**PROJECT:** **MOBILE AREA WATER AND SEWER SYSTEM**
**Low Head Pump Building Renovations**

**GMC PROJECT NO. AMOB230011**

**RE:** **ADDENDUM NO. 2 AND ACKNOWLEDGEMENT OF RECEIPT OF ADDENDUM NO. 2**

**ADDENDUM NUMBER 2** **September 29, 2026**

**OVERALL ARCHITECTURAL SITE PLAN**

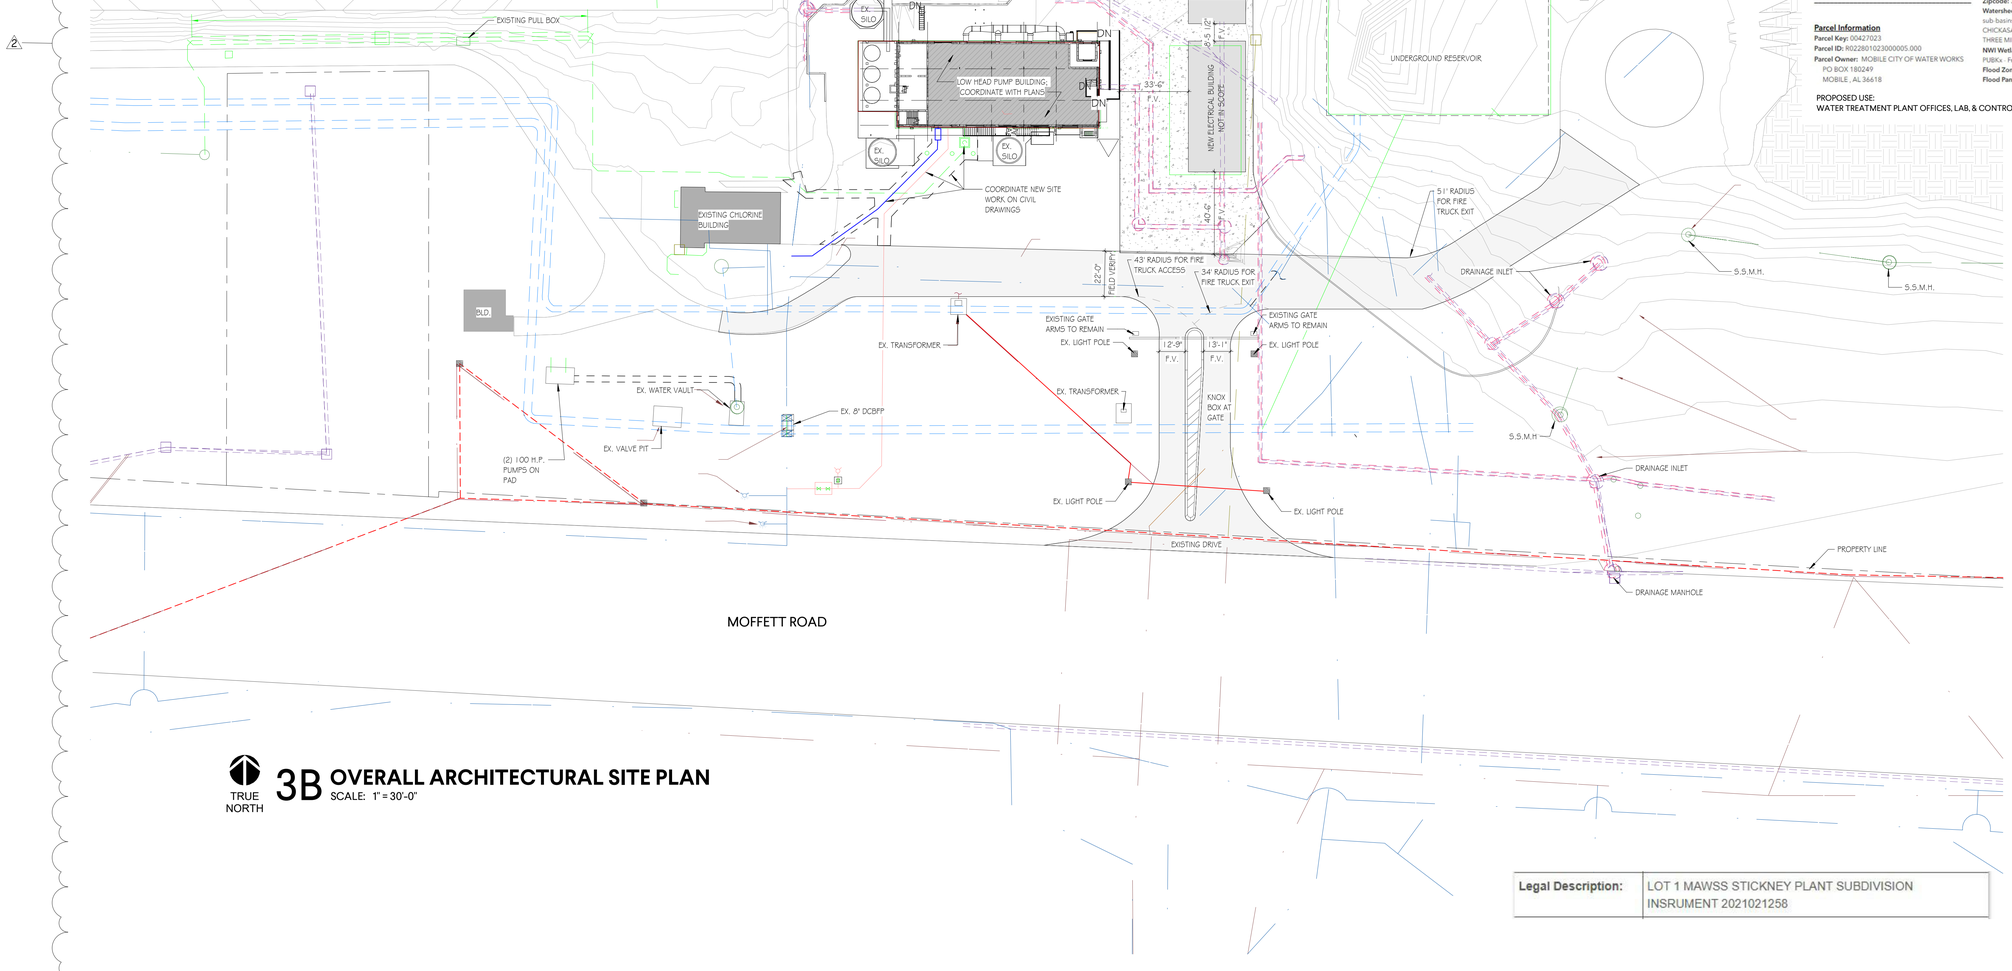
B. See attached revised drawing A0.01 Architectural Site Plan. Routing of sanitary sewer as well as fire lines and fire alarm system wiring has been updated to reflect changes to the site civil design.

**SECOND FLOOR - FLOOR PLAN**

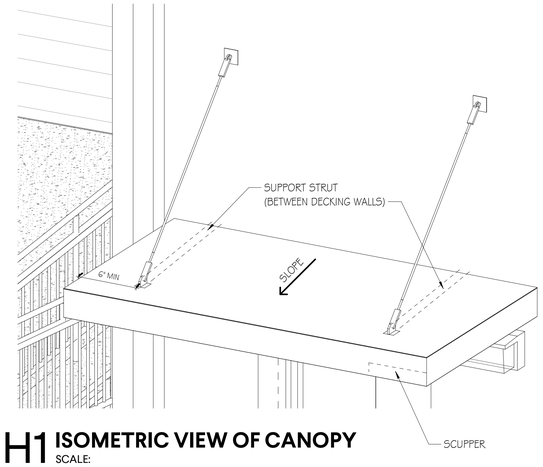
C. See attached revised drawings A1.01 and A5.01 for 'floor addition' where 2nd Floor shall be extended to the new elevator shaft.

**LOW HEAD LVL 2 FLOOR PLAN - FIRE PROTECTION**

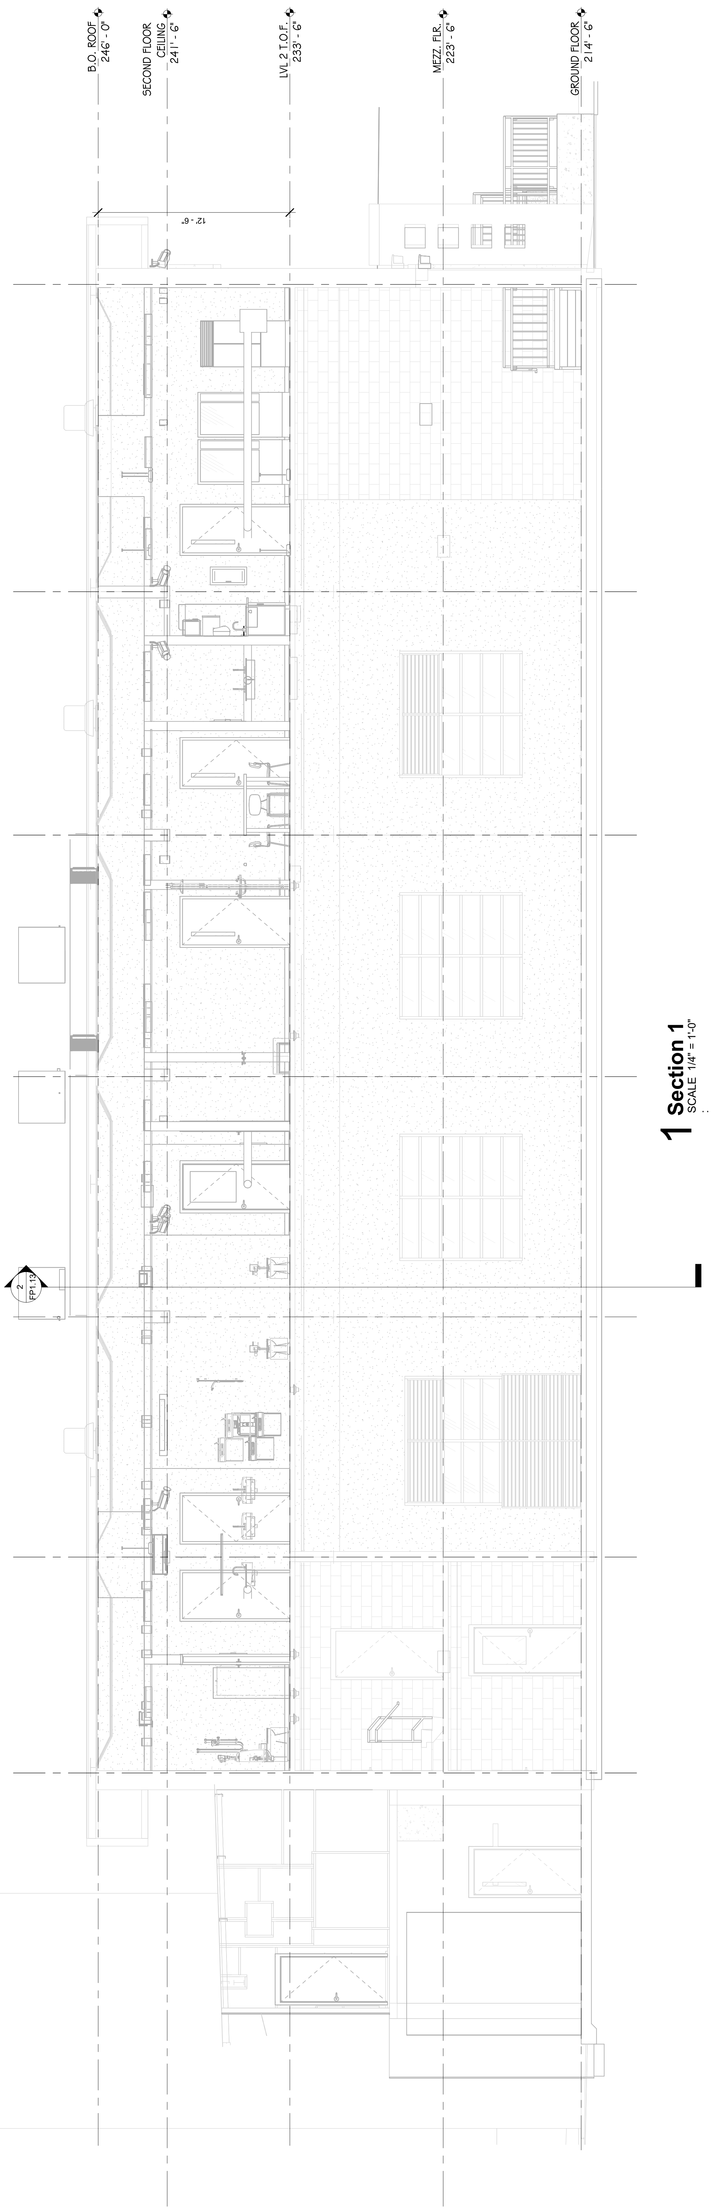
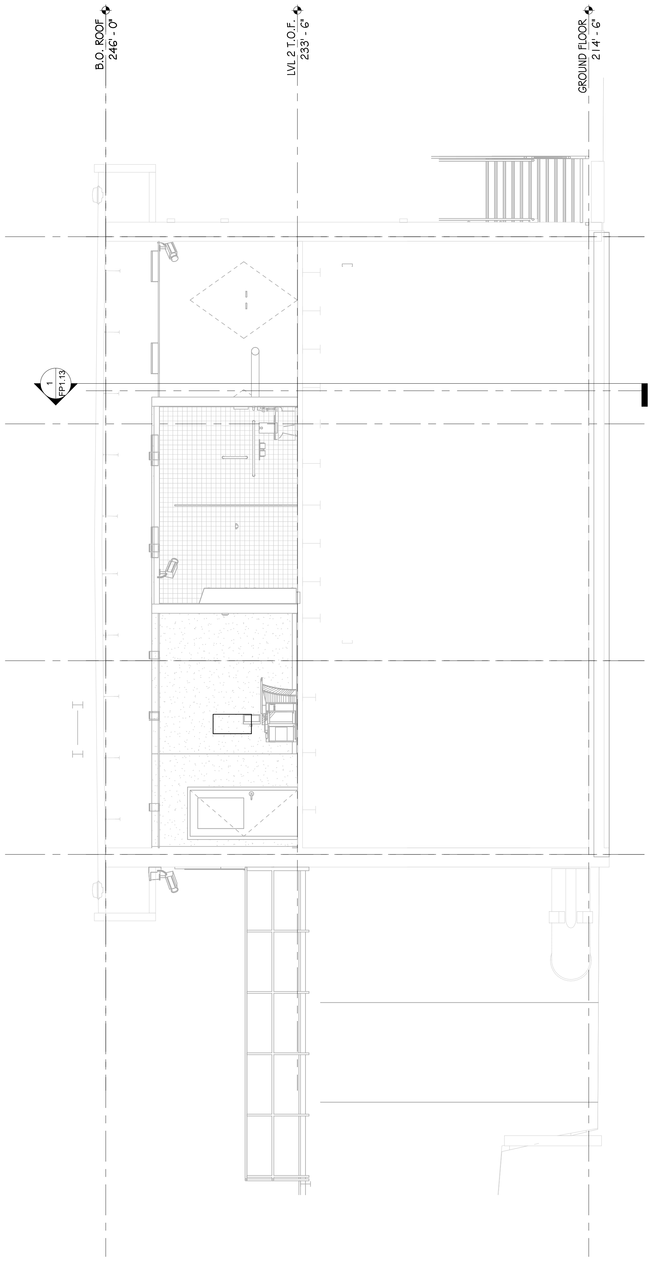
D. See attached revised drawings FP1.12, FP1.13, M1.12, M6.01, P0.01, P1.11, P1.12, P1.21, P1.22, and P9.01 as well as revised Sections 237416 & 237417 for various changes including, but not limited to, direction of fire protection, changes to plumbing fixtures, internal piping for process water, clarification to RTU's, picked up range hood, and general cleanup.

K. Special Hazard Suppression RFIs
   a. Please confirm the demo scope of existing suppression and any new install suppression scope for project. Drawings include picture below of one of the existing suppression cylinders. Is the intent to demo and store the pictured suppression system in the 2nd floor storage room along with the other system in the 2nd floor electrical control room?

b. Are there plans to protect any spaces with special hazard suppression on the 2nd floor? Maybe in the following rooms below? If yes, can a spec be provided for this scope. It is important to note FM-200 is being phased out, so If the volume of the new protected spaces vary substantially then you may not be able to reuse the same agent.
      i. PLC/MCC 215

**ANSWER: See attached revised Fire Protection drawings for updates.**

**ANSWER: See attached revised Fire Protection drawings for updates.**

**LOW HEAD LVL 2 FLOOR PLAN - HVAC DUCTWORK**

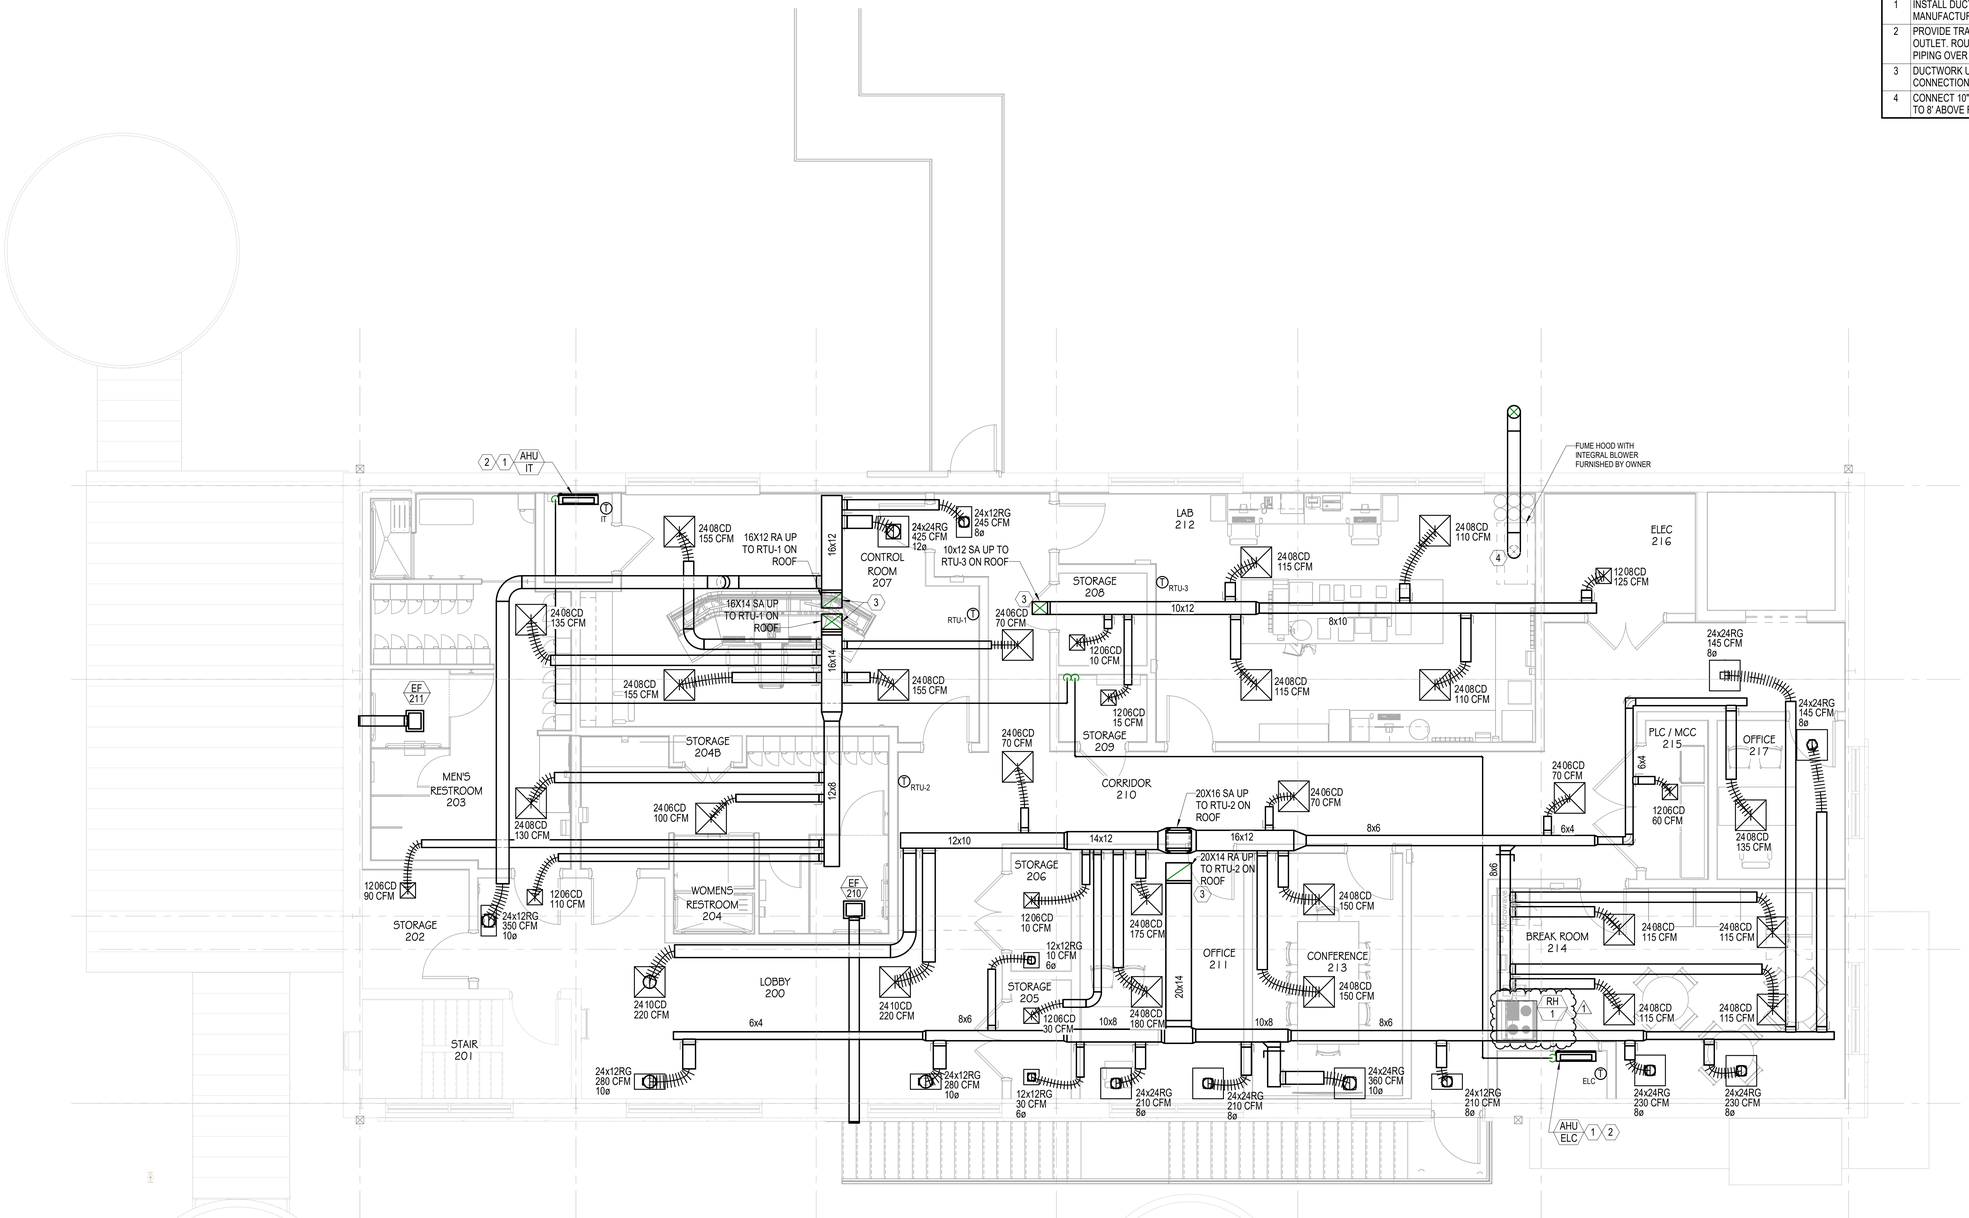
U. A1.01 has a note that states GC to provide and install new exhaust fan louvers between frame lines 2-3 & between frame lines B & D. However, A4.01 note E6 states all louvers are to remain as is (the louvers between frame lines B&D are specifically called out as having this note). Please clarify and state the type of louver if replacements are needed as several types of louvers are listed in spec 233719.

**ANSWER: Coordinate with mechanical for mechanical devices (louvers, etc.) that penetrate the exterior wall. See M1.12 for mechanical devices (louvers, etc.) locations. The note on A1.01 is specifically referring to new mechanical devices (louvers) and direct the viewer to coordinate with mechanical. Architect will select color from mechanical suppliers submitted devices and colors available. *Note: A4.01 does not show the new mechanical devices (louvers).* The note on A4.01 refers to the existing louvers and windows that remain after demolition.**
